Access Compliance Report Public Rights-of-Way (RR Crossings)

Intersection ID: 10025341	Main Street: E_7TH_ST	Location: N/A
ADA ID: 5F0435F2B209	Overall Compliance: No	Severity Score: 0.0
Codes/Mitigation Info/Possible Solution		Field Measurements/Component Compliance

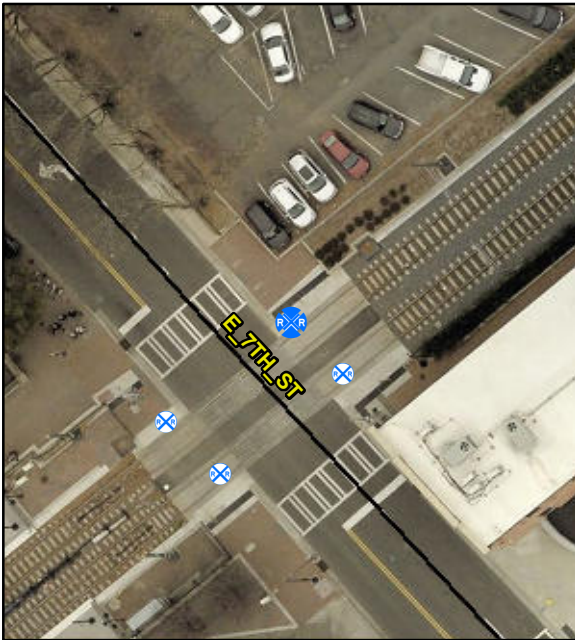
**Remove & Replace Detectable
Warning System. Provide Pedestrian
Gate. Remove & Replace Walking
Surface Adjacent to Rail.**

Compliance	Description	Data
Yes	DWS Provided?	Yes
Yes	DWS Contrast?	Yes
Yes	DWS Width (in)	Yes
Yes	DWS Length (in)	24.0
No	DWS Offset (in)	70.0
No	Pedestrian Gate?	No
N/A	DWS Outside Gate?	Yes
N/A	Rail Type?	LightRail
No	Flangeway Gap (in)	2.5
Yes	Sidewalk Width (in)	215.0
